Technical Memorandum

Date: April 21, 2016

Re: Addendum to Transportation Study
for the Southfort Area Structure Plan
in the City of Fort Saskatchewan

**CITY OF FORT SASKATCHEWAN
SOUTHFORT TRANSPORTATION STUDY - ADDENDUM
INTERSECTION CONTROLS -
FULL DEVELOPMENT OF SOUTHFORT**

EXHIBIT ES-A1

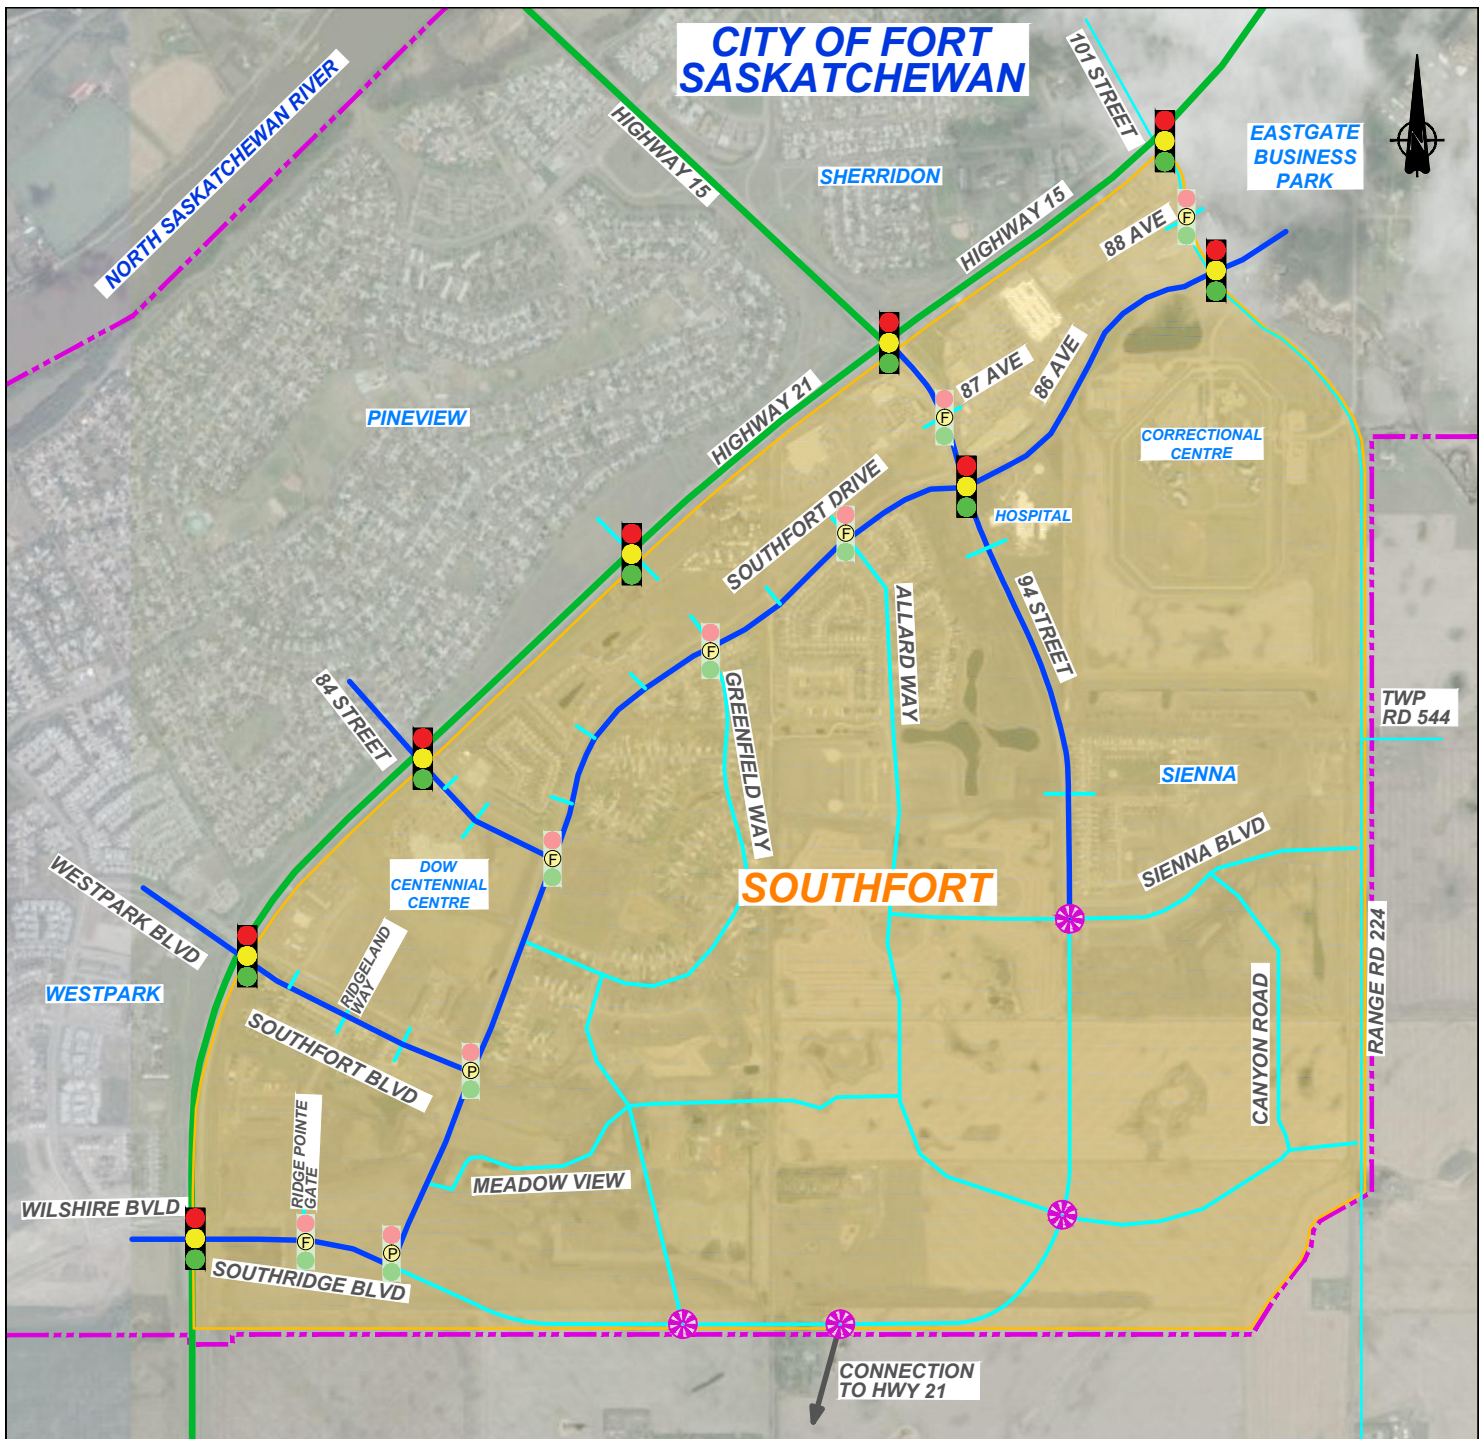
1. *Change the designation of the south end of Southfort Drive between Southfort Boulevard and Southridge Boulevard from a collector roadway to an arterial roadway, with traffic signals at both intersections.*

The City has indicated a desire to maintain consistency along the Southfort Drive corridor to Southridge Boulevard, and accordingly, we have prepared an exhibit (**Exhibit ES-A1**), identifying Southfort Drive as an arterial roadway throughout the Southfort Area.

2. *Designate the roundabout intersections along 94 Street as intersection control to be reviewed at the time of construction.*

Exhibit ES-A1 has been revised to show that roundabout intersections along 94 Street / Southridge Boulevard should be reviewed at the time of implementation to confirm their suitability. We also suggest that this corridor be reviewed during the Transportation Master Plan update.

FOUR LANE COLLECTOR - TYPICAL CROSS-SECTION

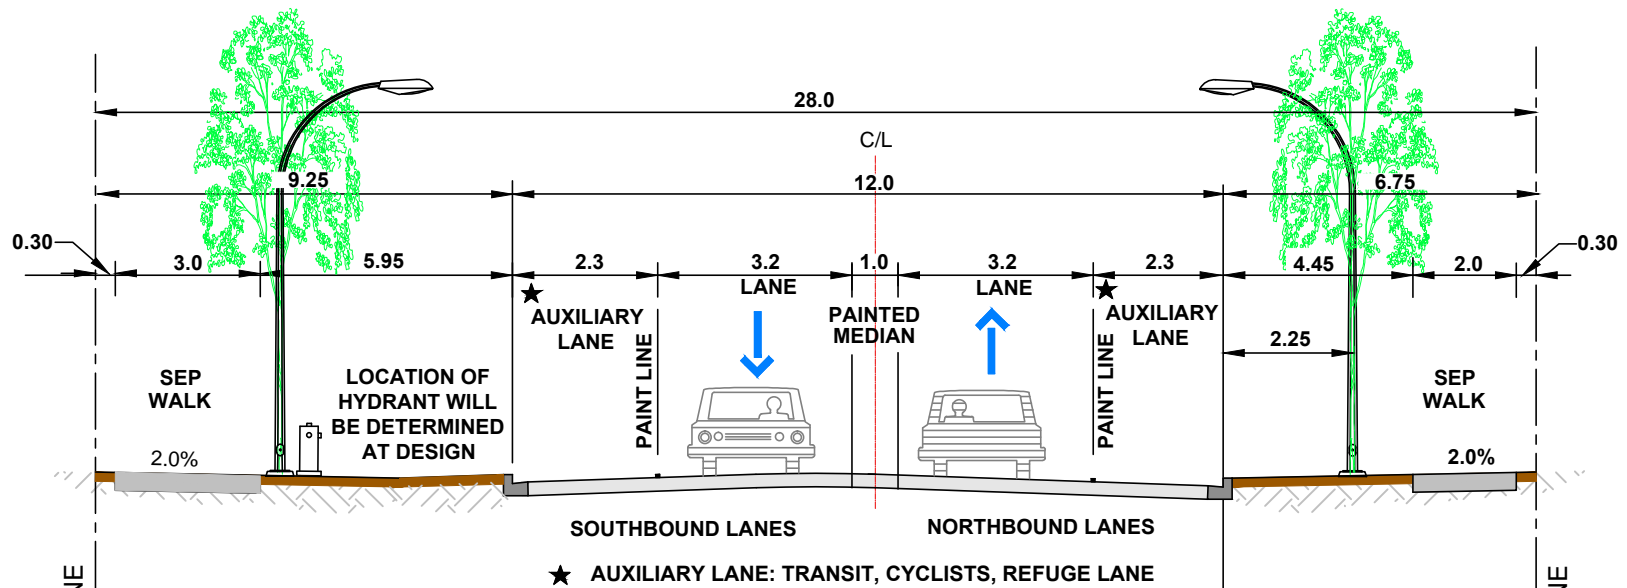
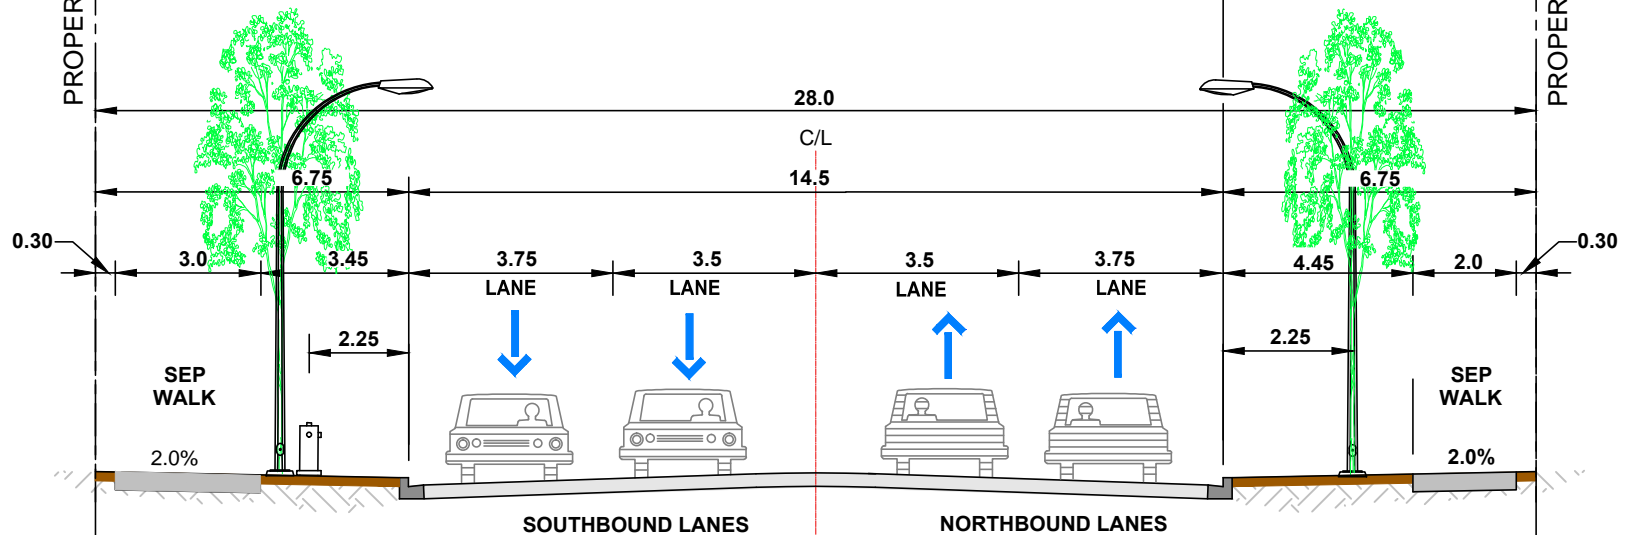
3. *Develop a revised cross-section for 94 Street / Southridge Boulevard based on a 28m wide right-of-way that would allow widening the carriage way to a 4-lane undivided standard.*

The proposed cross-section is shown on **Exhibit A1**, and is based on initially constructing to the City's 12.0m wide collector roadway, in accordance with the recommendations in the original report, and then, if required in the future, widening to 14.5m to provide a 4-lane undivided roadway. Careful consideration for locating infrastructure outside of the widened area as shown would provide the most cost effective approach.
